DEPARTMENT OF THE NAVY

5090
Ser 046/169
1 Sep 98

We are writing in response to your letter of August 14, 1998, concerning the Installation Restoration (IR) Site 57 Remedial Investigation Work Plan. We appreciate you taking the time to review this document and provide your comments to us. The Navy has been trying to get the public involved in remediation activities at Naval facilities to ensure that everyone, especially in nearby communities, understands what is being done and to address all concerns prior to conducting fieldwork. The only way this can be done is by receiving input from active citizens, like you.

REF: IR Site 57, Remedial Investigation Work Plan

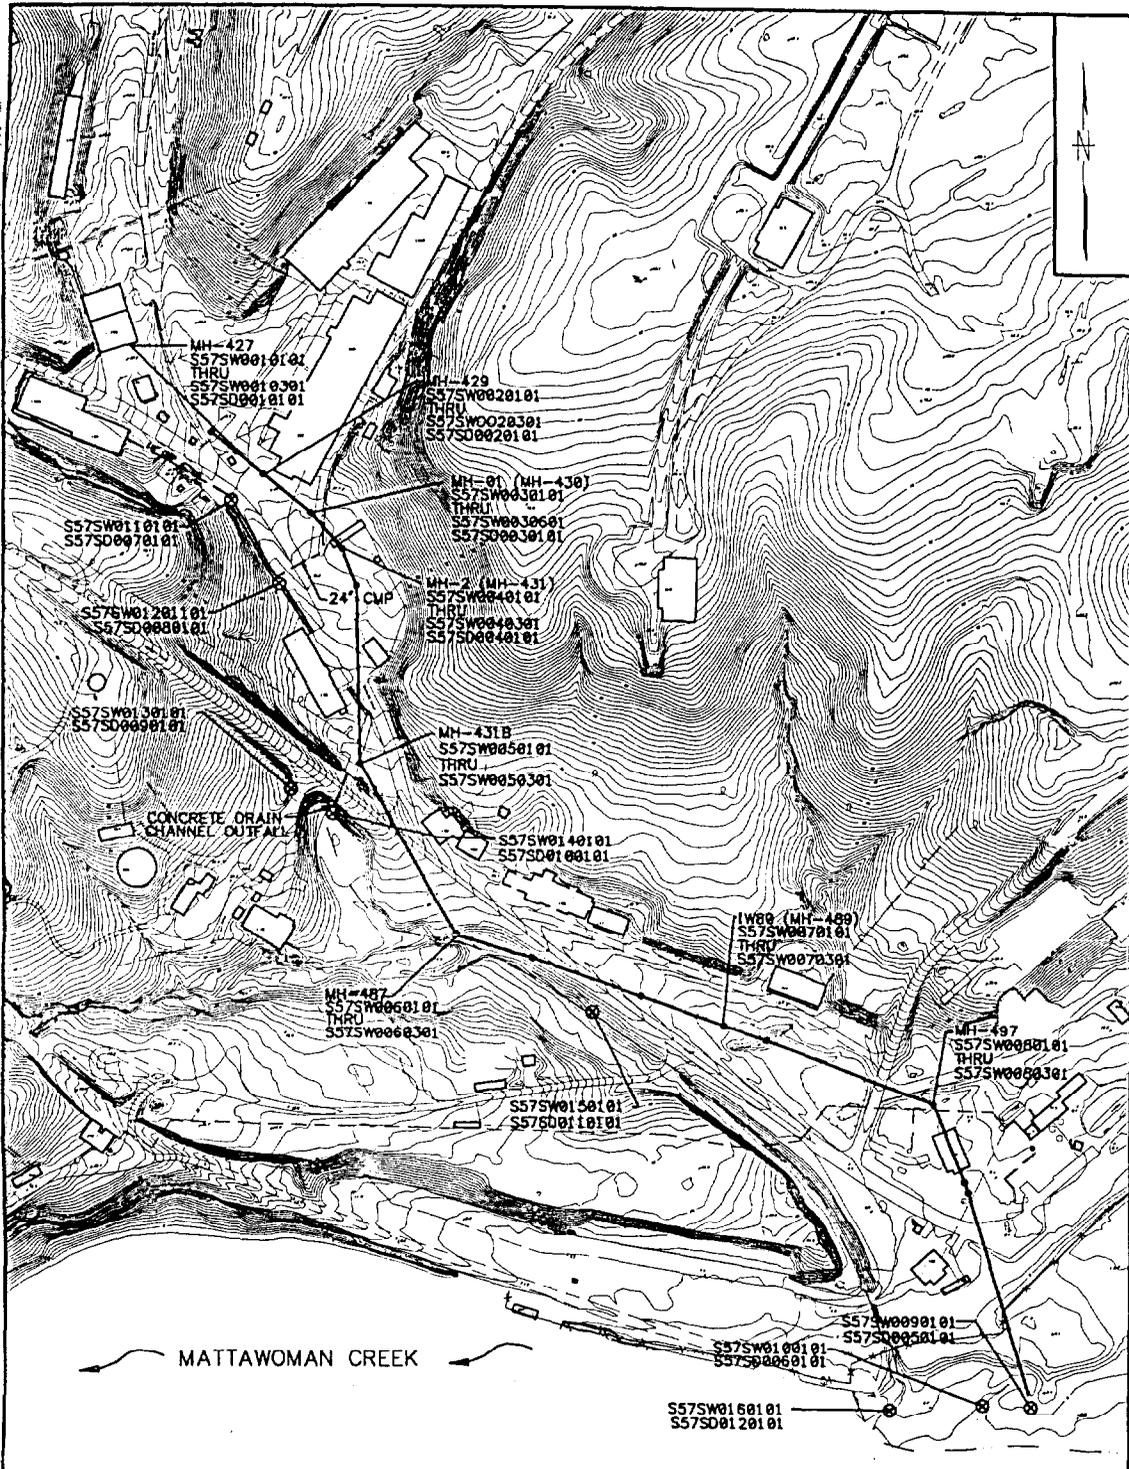
1. The Executive Summary identifies in ES-1 some 30 water samples to be taken with respect to the storm sewer system and 6 for sediment samples. Table 3-2, however sites only one (1) sample each for assessing:

a. "stormwater at the discharge" -- outfall of the 36' pipe at the Mattawoman Creek (S57SW009 and S57SD005)

b. "Sediment at the discharge"--50' downstream from the outfall to Mattawoman Creek (S57SW010 and S57SD006)

c. "Examining for other contaminants"--at the discharge of the concrete channel to Mattawoman Creek(S57SW016 and S57SD012)

Does this represent a total of three or six samples?

In any event this is not an adequate sampling for measuring contaminants at what has to be a primary point of consideration. One of our primary objectives in this investigative work must be to assure ourselves that there is no discharge of contaminants from site 57 by whatever source into the Mattawoman Creek.

The proposed sampling at the above discharge points into the Mattawoman Creek should be significantly increased and scheduled over a period of time so that we can have confidence in the results.

In addition, Table 3-2 from the work plan, which has been reduced in size for inclusion in this letter as enclosure (2), provides details on the samples to be taken and their locations. The locations of the samples referenced in the table are shown on Figure 4-3 of the work plan. This figure has been included as enclosure (3).

Based on this information, the sample numbers that you have listed in your comment refer to 6 separate samples at 3 distinct locations: 3 water samples and 3 sediment samples. A surface water sample (S57SW009) and a sediment sample (S57SD005) will be taken at the outfall of the 36-inch pipe at Mattawoman Creek. A surface water sample (S57SW010) and a sediment sample (S57SD006) will be taken 50 feet down stream from the outfall to Mattawoman Creek. And, a surface water sample (S57SW016) and a sediment sample (S57SD012) will be taken at the discharge of the concrete channel to Mattawoman Creek. Again, these samples are shown on enclosure (3).

To address the first part of your comment, it is important to note that this storm sewer receives industrial wastewater, such as cooling water from the powerhouse, and is regulated by the Maryland Department of the Environment (MDE) under the National Pollutant Discharge Elimination System (NPDES) as Industrial Wastewater Outfall (IW) 80. The NPDES permit for our Activity sets a limit of 100 parts per billion (ppb) of trichloroethylene (TCE) for IW 80. The permit became effective on February 1, 1998, and requires quarterly sampling for TCE. However, beginning in January 1999, IW 80 will be sampled monthly for TCE. NPDES sample results to date for TCE at IW 80 are listed below:

From this data, we can see that TCE from IR Site 57 is already entering the Mattawoman Creek at levels below the permitted limit of 100 ppb.

Also, as discussed in previous Restoration Advisory Board meetings, a removal action will be conducted prior to this RI study to decrease, and hopefully eliminate, the discharge of TCE to the Mattawoman Creek. The removal action involves the relining of approximately 800 feet of the storm sewer pipe to eliminate TCE-contaminated groundwater infiltration into the storm sewer.

Your final statement in your first comment suggests that we increase the number of samples at the discharge point and schedule them over a period of time so that we can have confidence in the results. This would be appropriate after a final site remediation has been conducted, to ensure that the remedial action was successful. We can discuss this issue again during the Remedial Design phase of IR Site 57, which is budgeted for fiscal year 1999.
